Name of Tender : Design, manufacture, assembly and testing at manufacturer's works; packing and transportation to site; supervision of erection, testing and commissioning of LT Switchgear Package for Tata Steel 1X40MW STG, Jamshedpur Project.

BHEL Tender Ref : T7H1P01239/ NIT_29650 Dated 04.10.2016

Replies to Pre-Bid Queries

Corrigendum-01 DTD. 14.10.2016

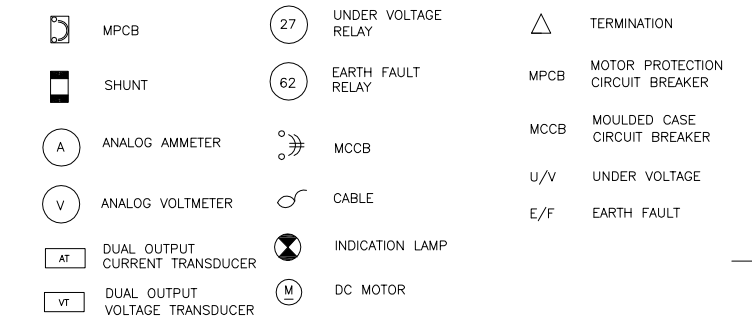
3.	<u>DCDB:</u> a) Please confirm the system voltage. b) Control schemes & switchboard single line diagram is not available in tender documents. Please provide the same.	a) The DC Voltage Level is 220 V. b) The Single Line Diagram for 220V DCDB was inadvertently missed in the specification. The same is attached herewith. Control Schemes for DCDB shall be designed based on the SLD and other requirements as mentioned in the Specification.
